CITY OF LACONIA
REGULAR PLANNING BOARD MEETING
Tuesday, January 6, 2026 - 6:30 PM
City Hall - Armand A. Bolduc City Council Chamber

6.1. PB2026-021; 604 Endicott St N (128-252-3.1)

Applicant proposes to amend their previous site plan approval to increase the size and capacity of the stormwater detention pond.

Re: 604 Endicott St N, Laconia Site Plan

Figure 1: Route 3 Flow

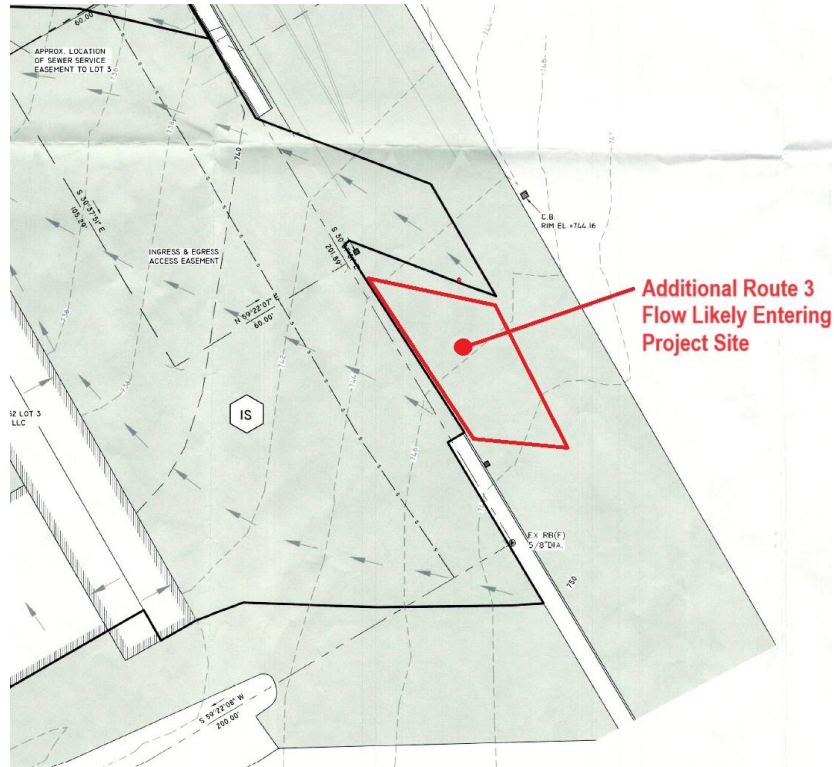
1. As stated previously, the hydrologic model appears to underestimate the area of Route 3 flowing onto 604 Endicott St N. No additional area was added to the revised stormwater calculations to account for this flow from Route 3. The existing and proposed flows onto 554 Endicott St N are likely slightly underestimated by the model. See Figure 1 and Figure 2 on the following page:

Figure 3: Rear Gravel (Existing Conditions Plan)

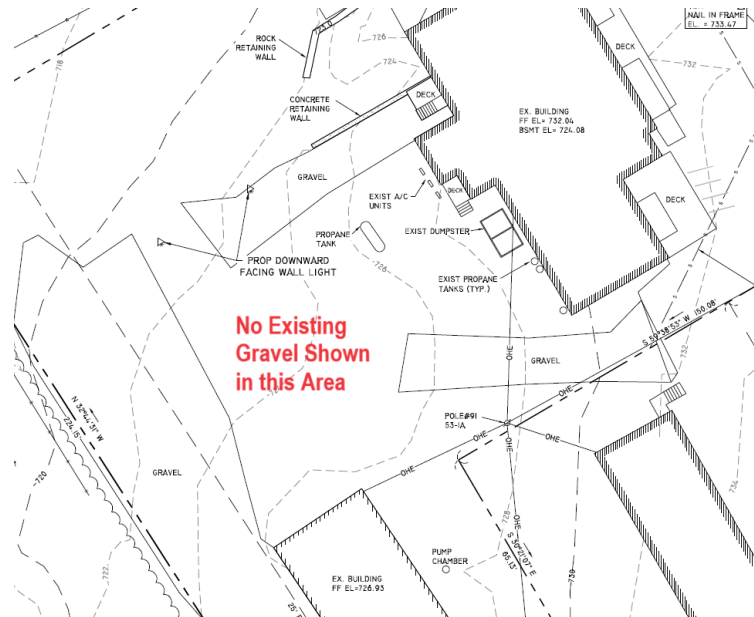
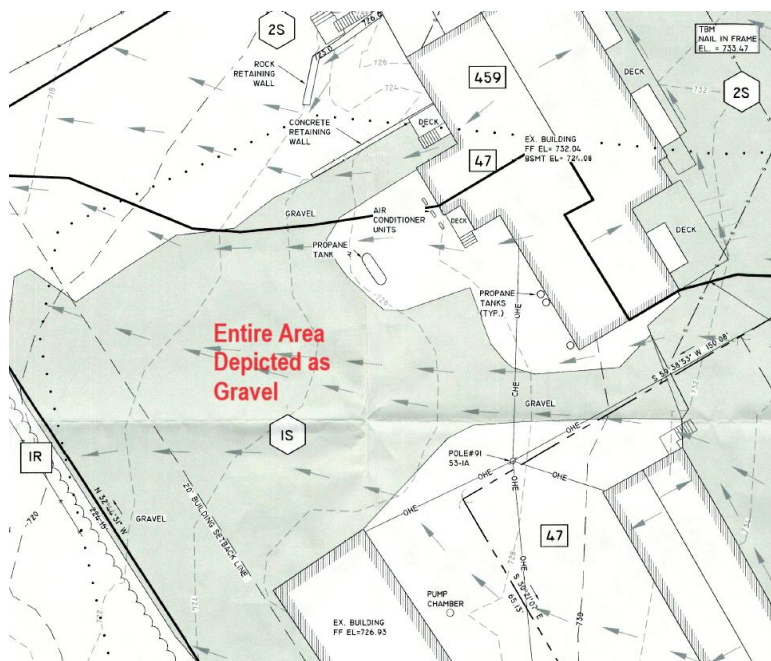
2. As stated previously, the Pre-Condition map depicts approximately 4,000 sq ft of existing gravel area that is not depicted on the Existing Conditions plan. This area was not added to the pre-development drainage model. If this gravel area does not exist then the model likely calculates the existing flows to be higher than they actually are. This, in turn, may result in proposed flows that are higher than the actual existing flows.

Figure 1: Route 3 Flow

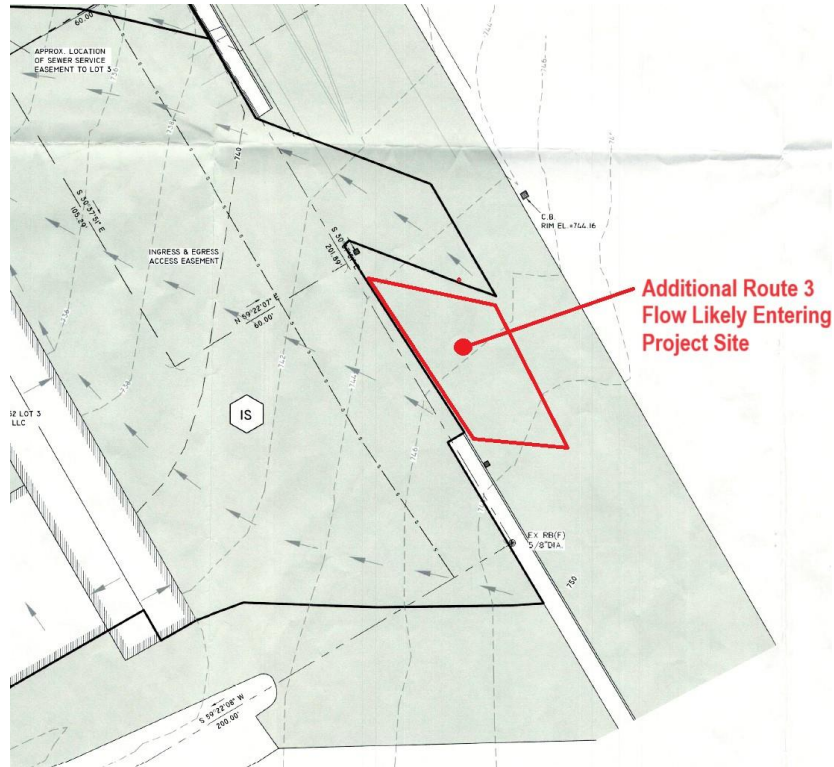
1. As stated previously, the hydrologic model appears to underestimate the area of Route 3 flowing onto 604 Endicott St N. No additional area was added to the revised stormwater calculations to account for this flow from Route 3. The existing and proposed flows onto 554 Endicott St N are likely slightly underestimated by the model. See Figure 1 and Figure 2 on the following page:

Figure 3: Rear Gravel (Existing Conditions Plan)

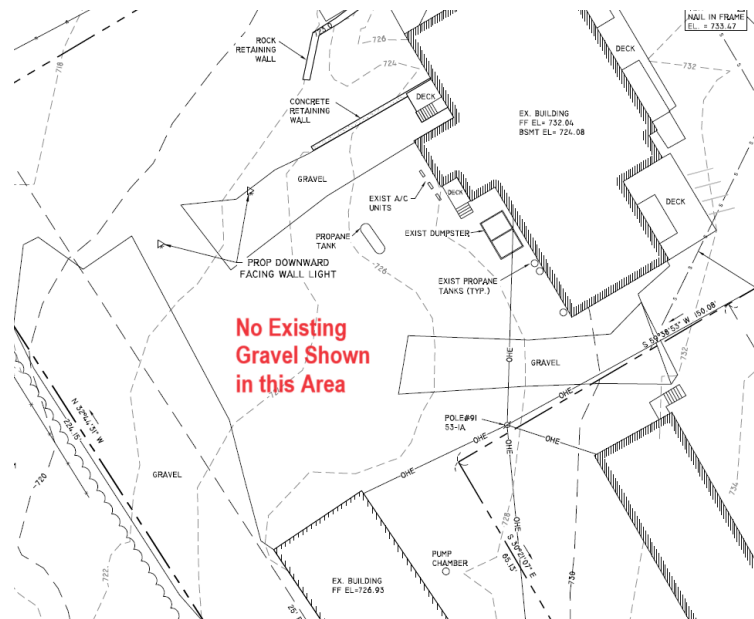
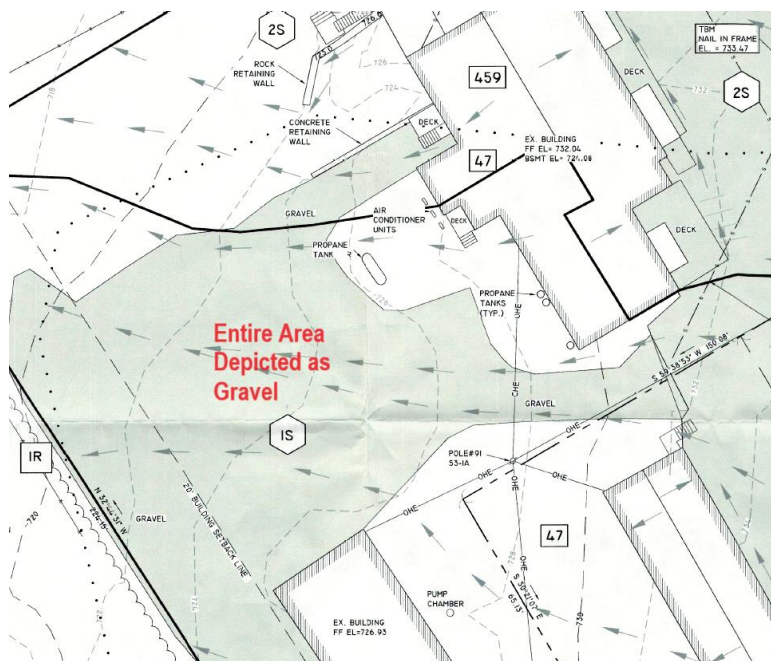
2. As stated previously, the Pre-Condition map depicts approximately 4,000 sq ft of existing gravel area that is not depicted on the Existing Conditions plan. This area was not added to the pre-development drainage model. If this gravel area does not exist then the model likely calculates the existing flows to be higher than they actually are. This, in turn, may result in proposed flows that are higher than the actual existing flows.
